# SRFR FIRE STATION 32

**SNOHOMISH REGIONAL FIRE & RESCUE**

**SITE PLAN REVIEW**

SEPTEMBER 5, 2025

## CIVIL SITE PLAN C100

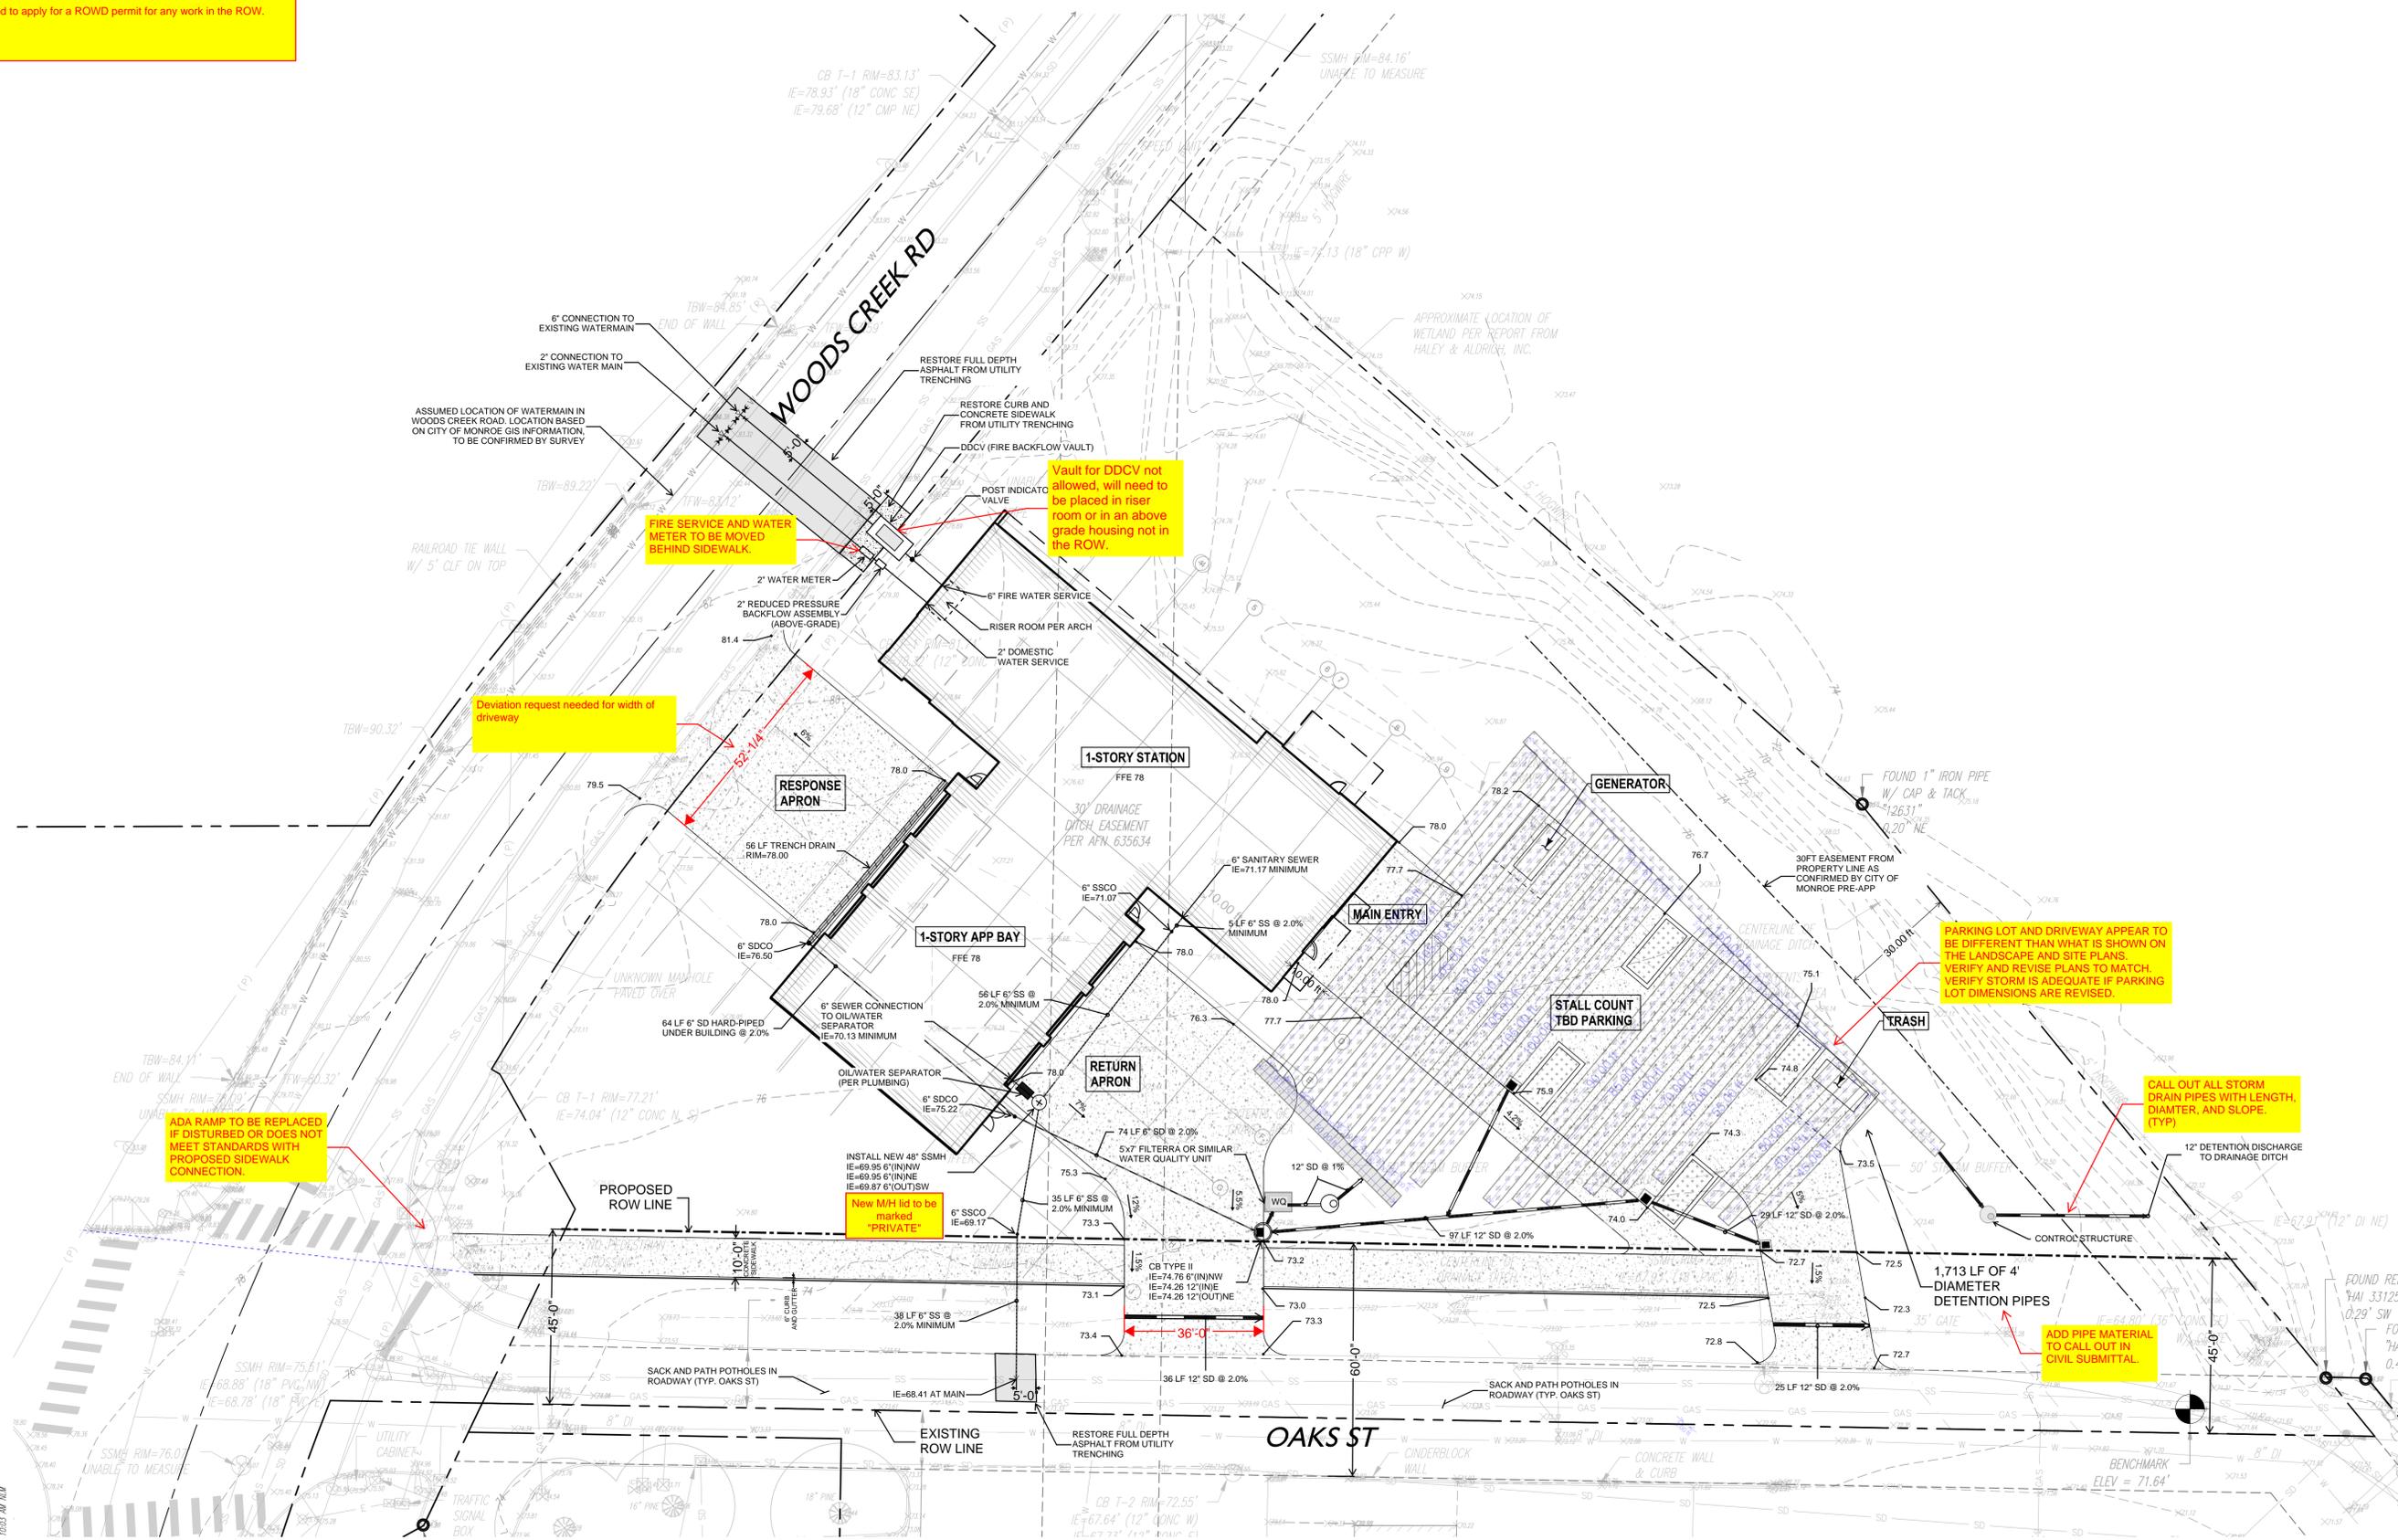
Will need to apply for a ROWD permit for any work in the ROW.

SHEET  
**Landscape Plan**  
Concept Site Plan  
& Notes

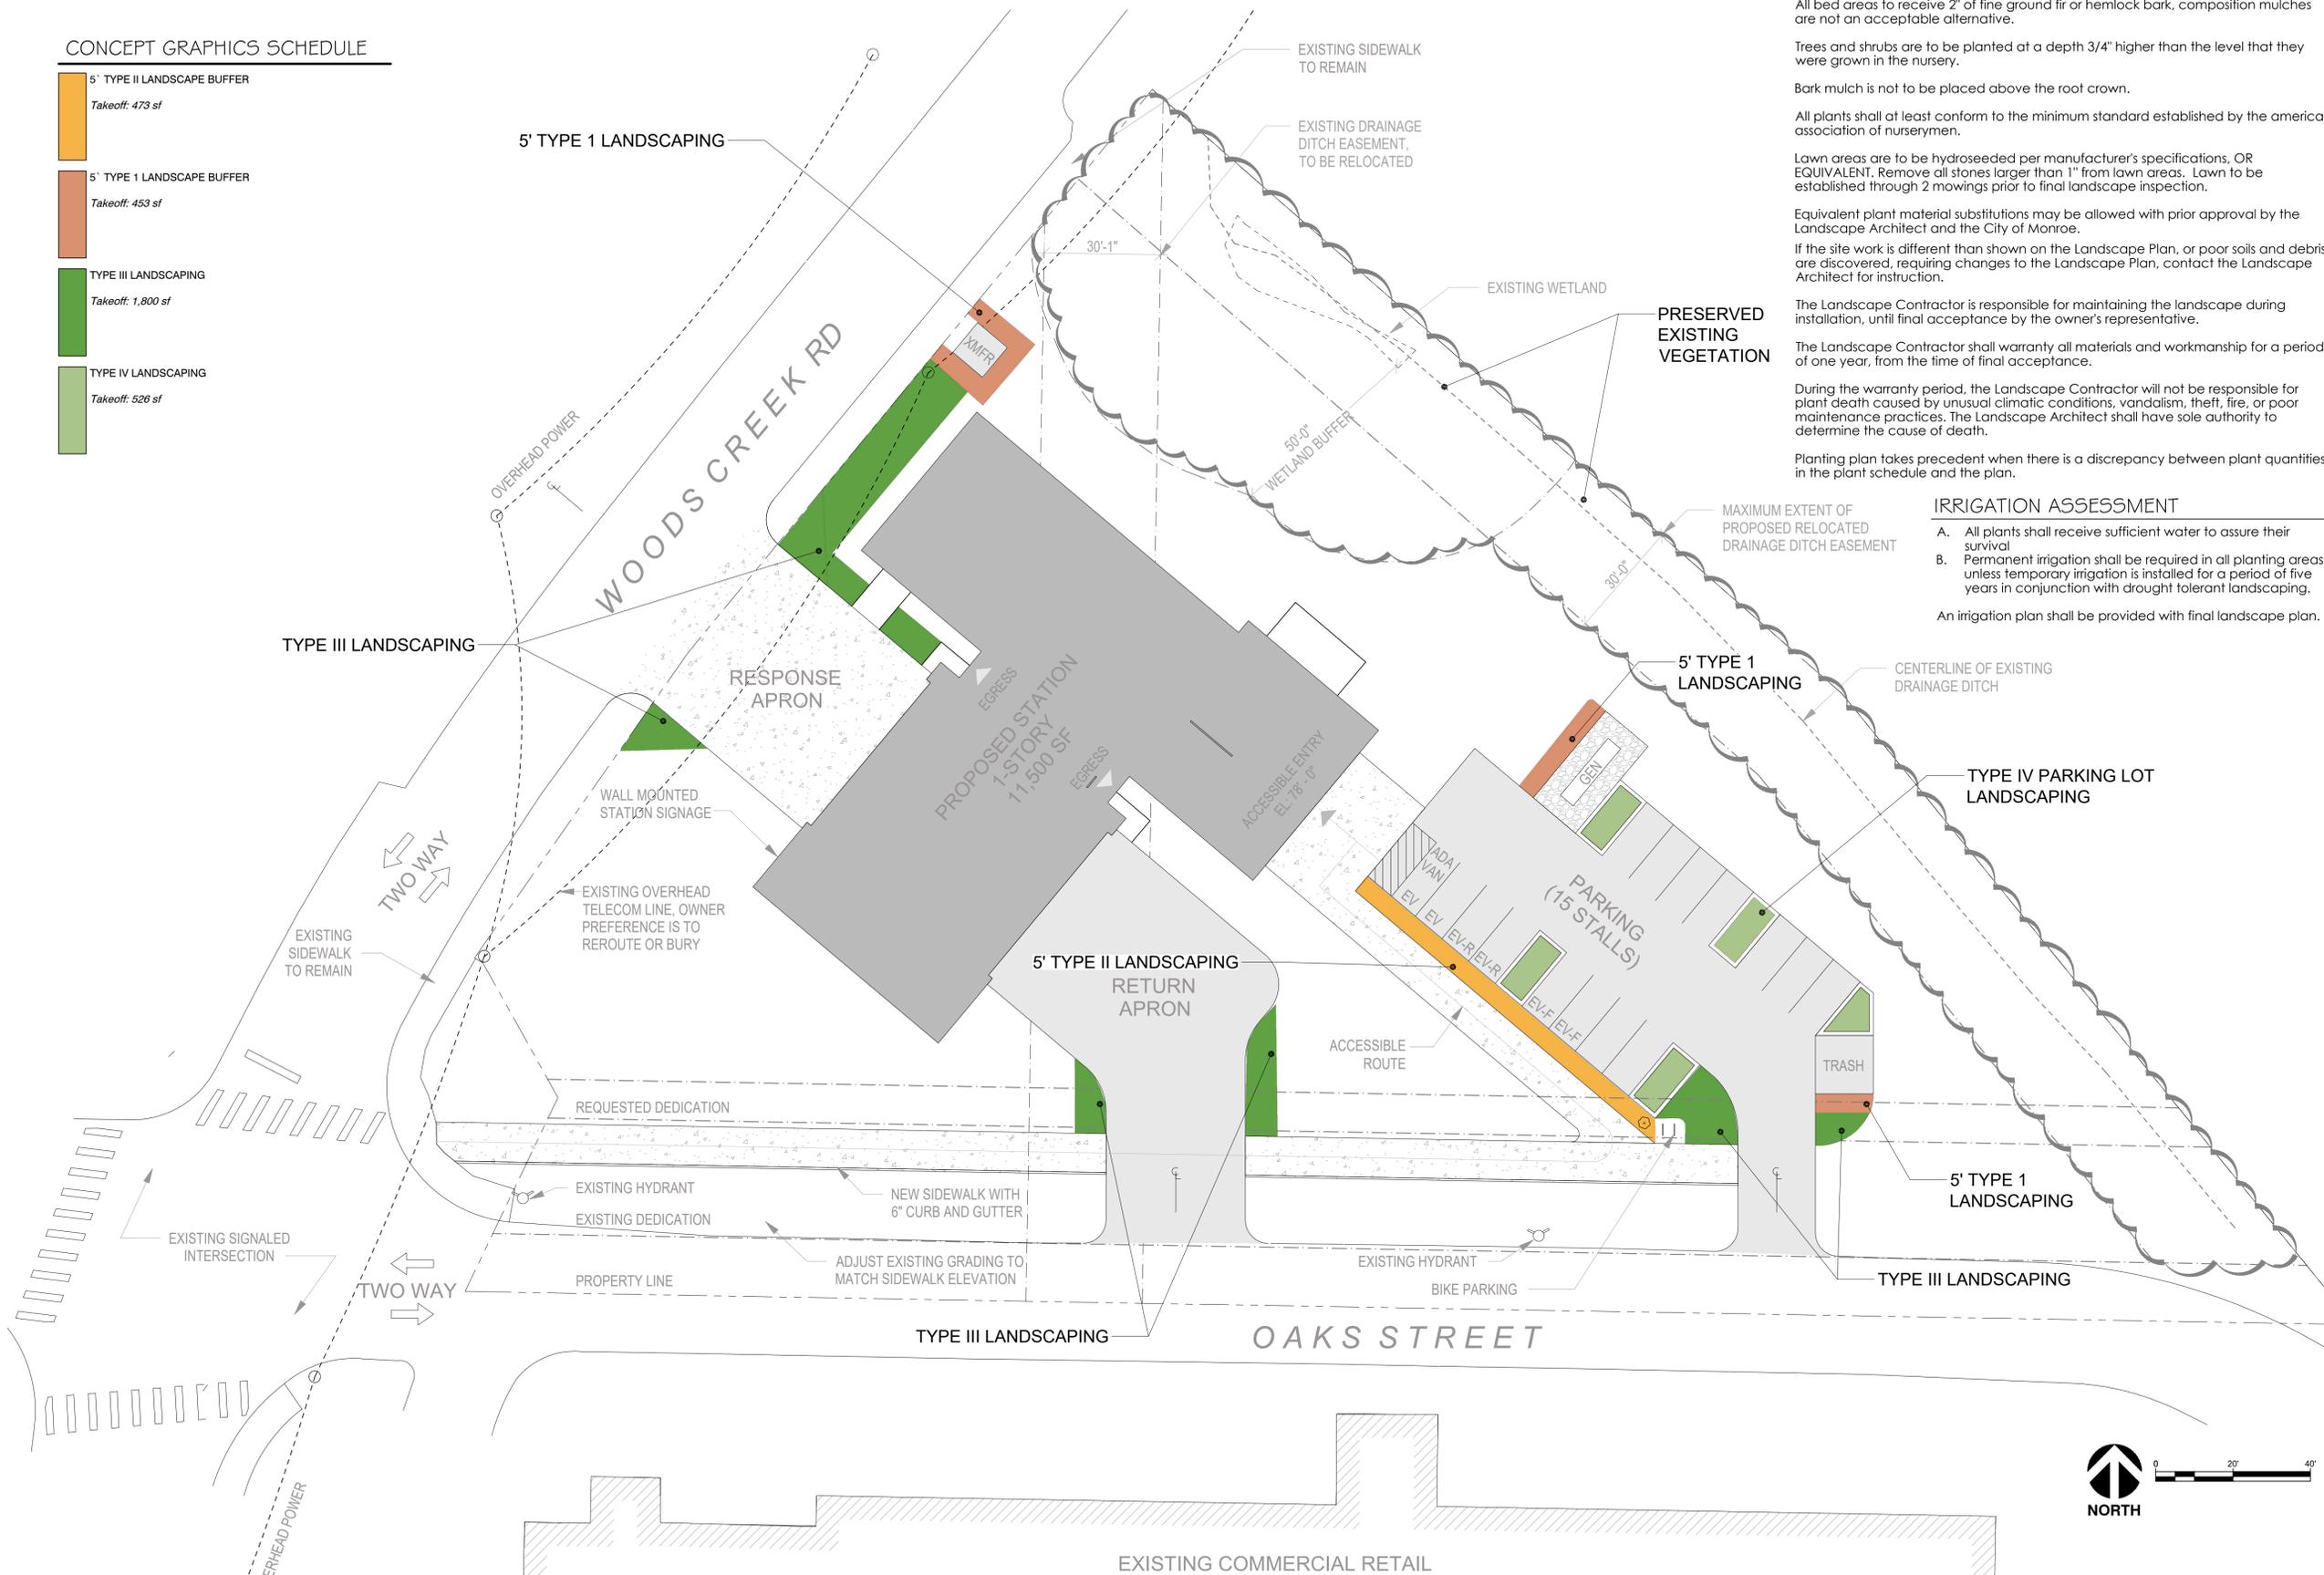
The parking lot and driveway are different on the civil plans than what is shown on the landscape and site plan. Revise drawings so all layouts match.

**Landscape Plan**  
**Planting Plan**

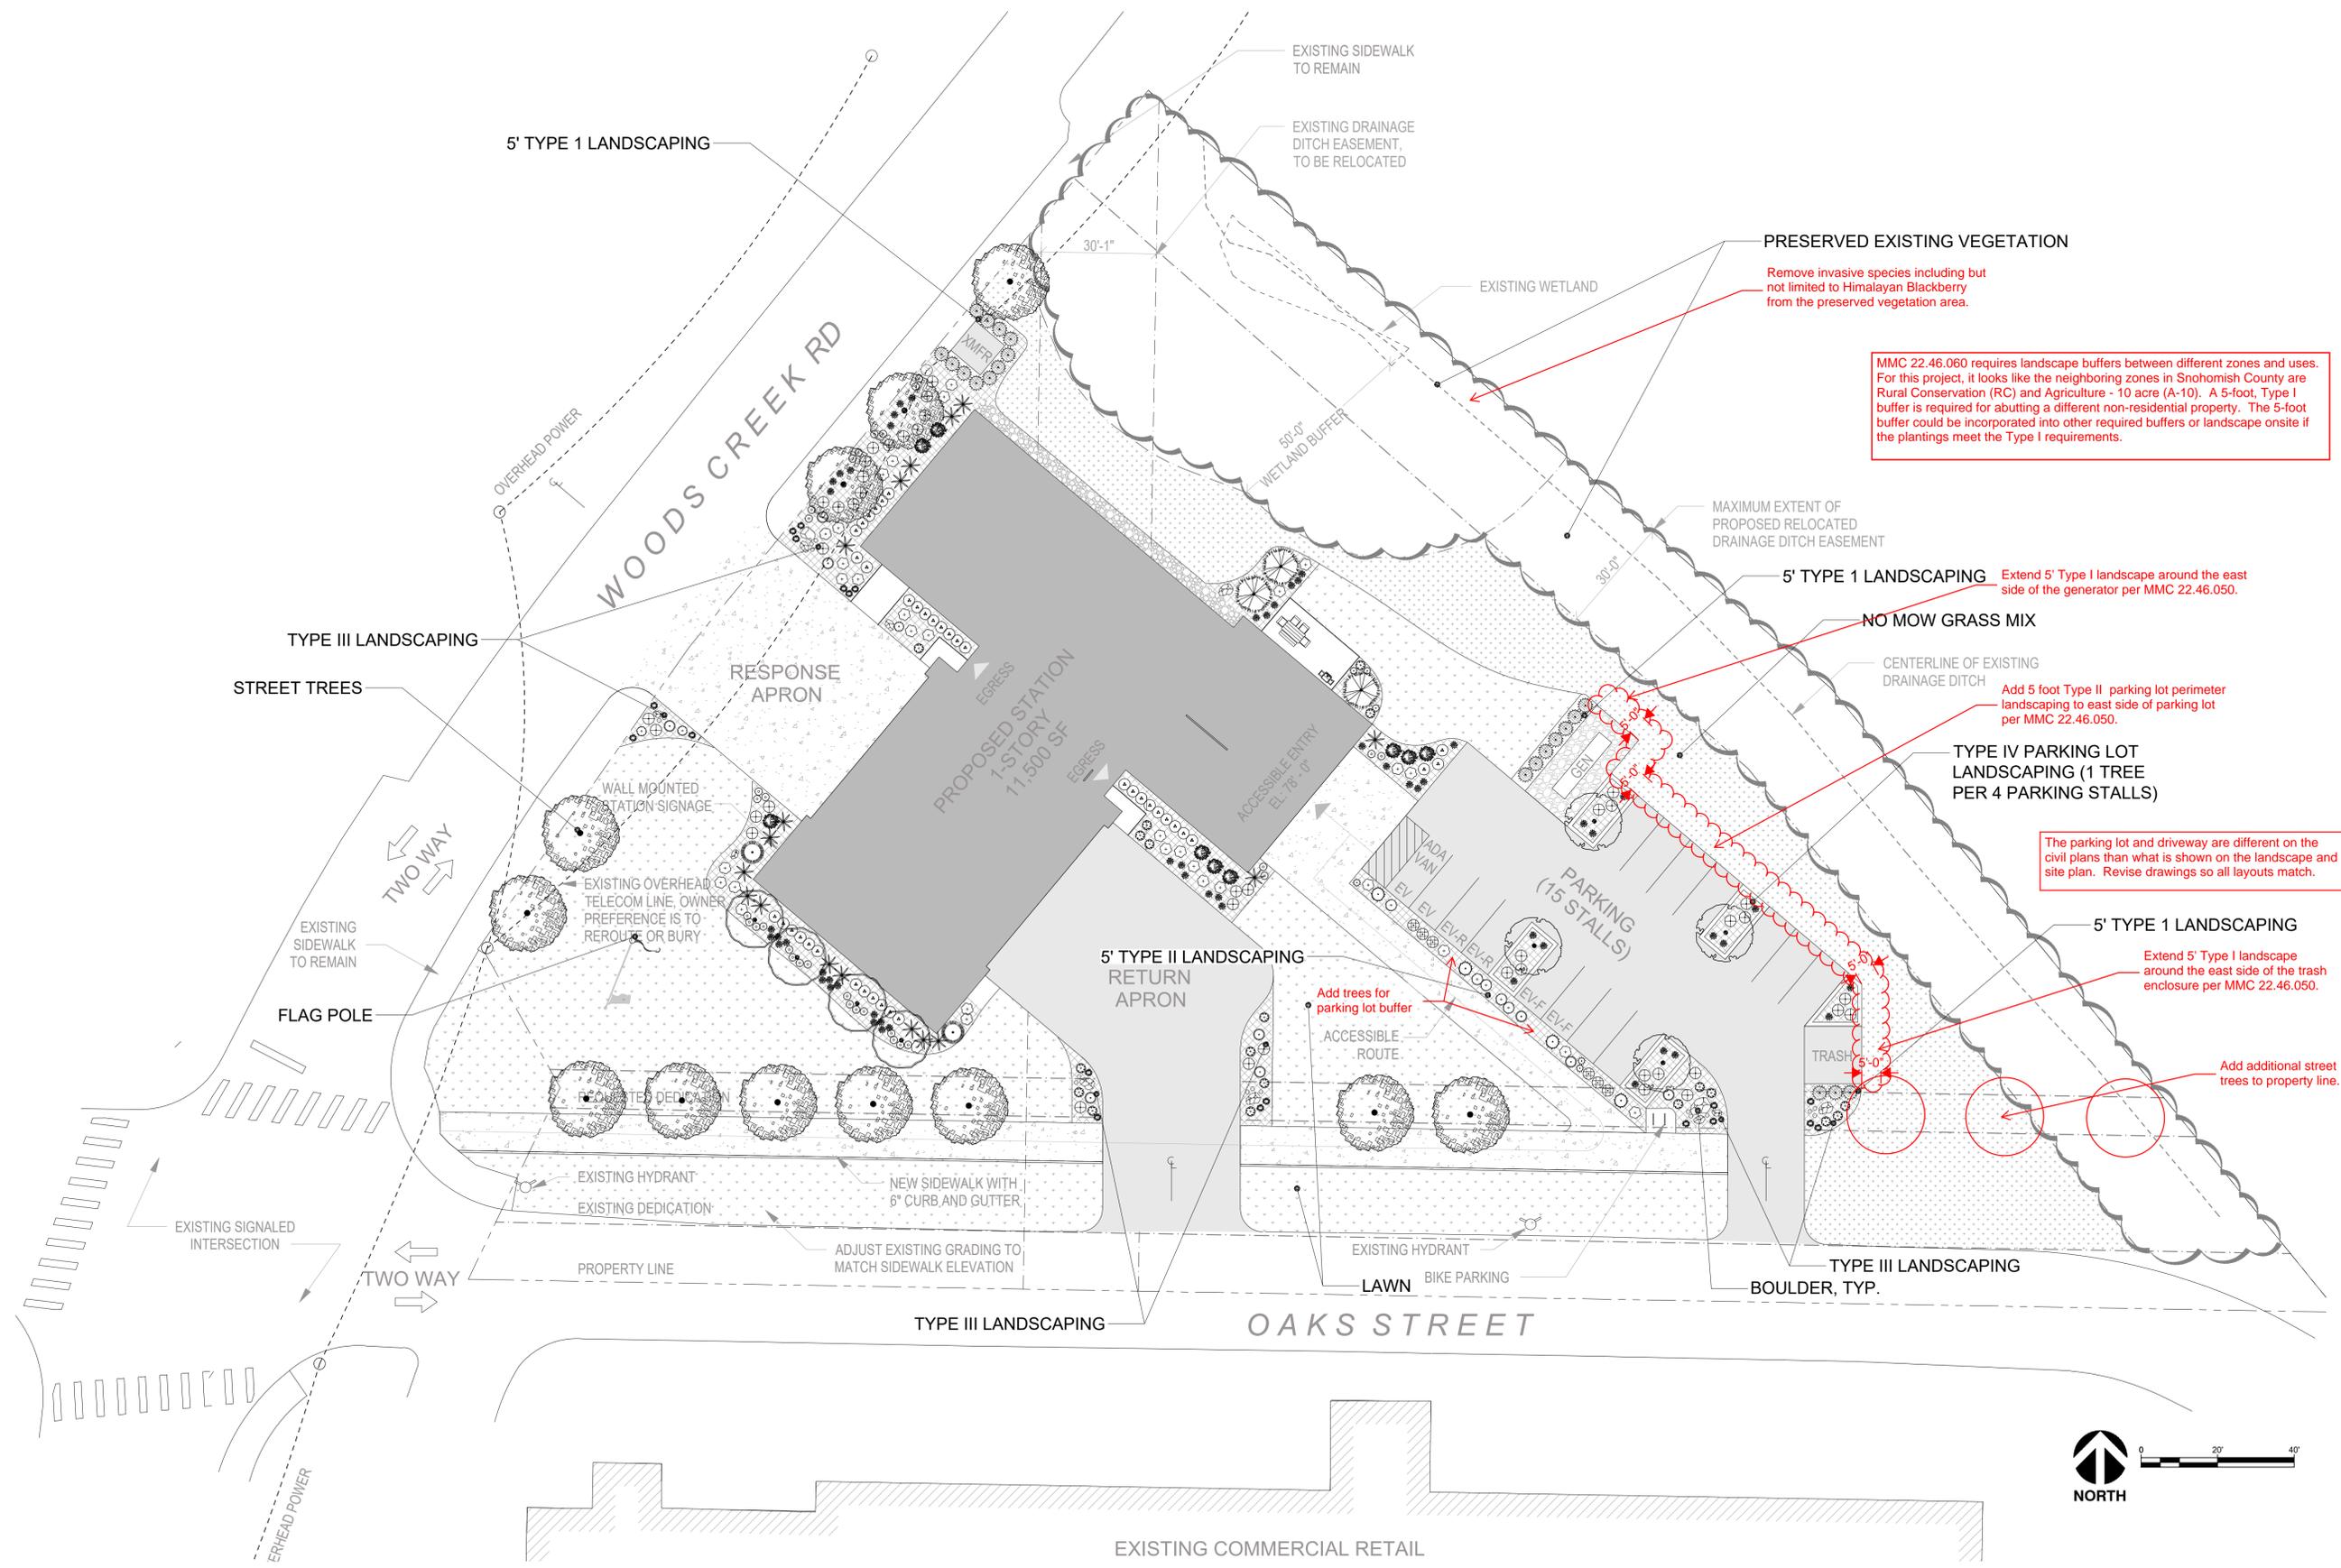
MMC 22.46.060 requires landscape buffers between different zones and uses. For this project, it looks like the neighboring zones in Snohomish County are Rural Conservation (RC) and Agriculture - 10 acre (A-10). A 5-foot, Type I buffer is required for abutting a different non-residential property. The 5-foot buffer could be incorporated into other required buffers or landscape onsite if the plantings meet the Type I requirements.
